Title Volvo Chassis - **Model VN**, Hood Release Cable Interference; Hood Release Cable Binding, Hood Latch Tough To Pull - **Model Year 2018 And Newer**

Volvo Model VN , VNL , VNM , VNR , VNX

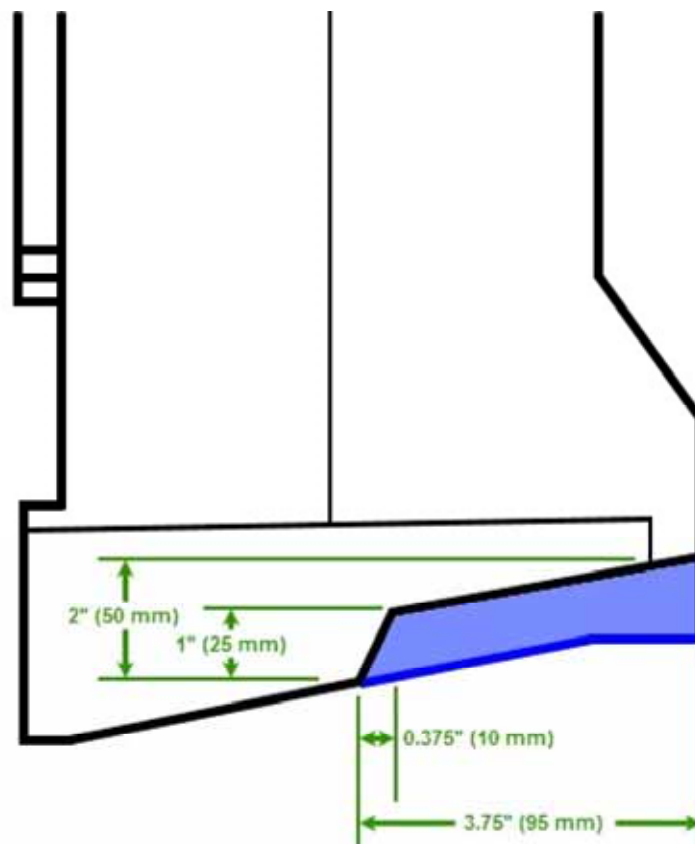
Cause For certain vehicles produced for model year 2018 and newer, the hood latch cable for the passenger side latch may be routed around a corner of the air box. This can cause the cable to bind when the hood release is pulled, and may lead to premature failure of the cable.

Solution For vehicles affected by this issue, the corner of the air box will need to be modified:

Using an appropriate tool, cut the corner off of the air box. This will allow the cable to straighten out and prevent fatigue. A diagram with approximate dimensions can be found below. The blue section is the portion that will be trimmed off:

An example of an air box before and after being trimmed can be seen below:
